To: Mark Westhues
From: John Funk, PE
Subject: Structural Inspection Concerns – 3rd Street White Box

**Re: 510 SW 3rd St. -Weld Inspection Report
Lee's Summit, MO**

JOIST CHORD REINFORCEMENT

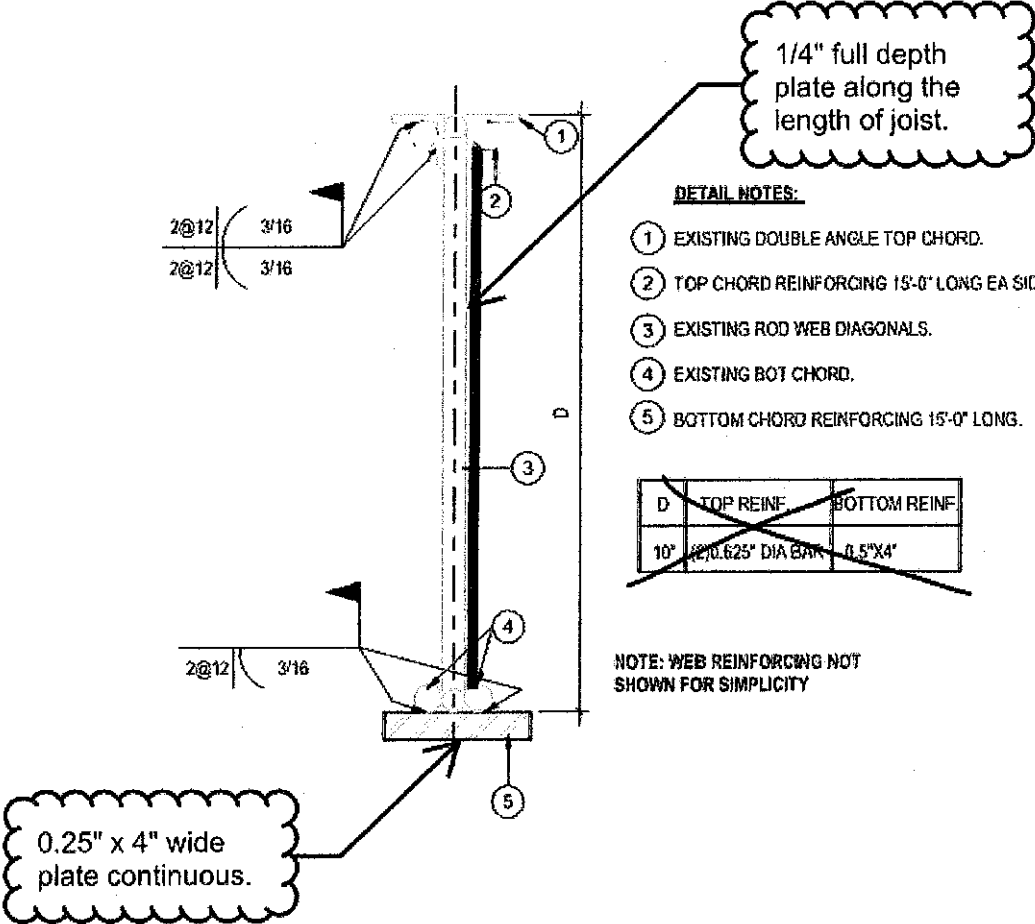
We understand that the 3rd party inspector is needing documentation regarding the additional joist web reinforcement shown in details 3/S101 and 6/S101. The steel erector has forwarded pictures for our review. Based on those photos, the channels are located close enough to the joist panel point that the angle reinforcement is not required.
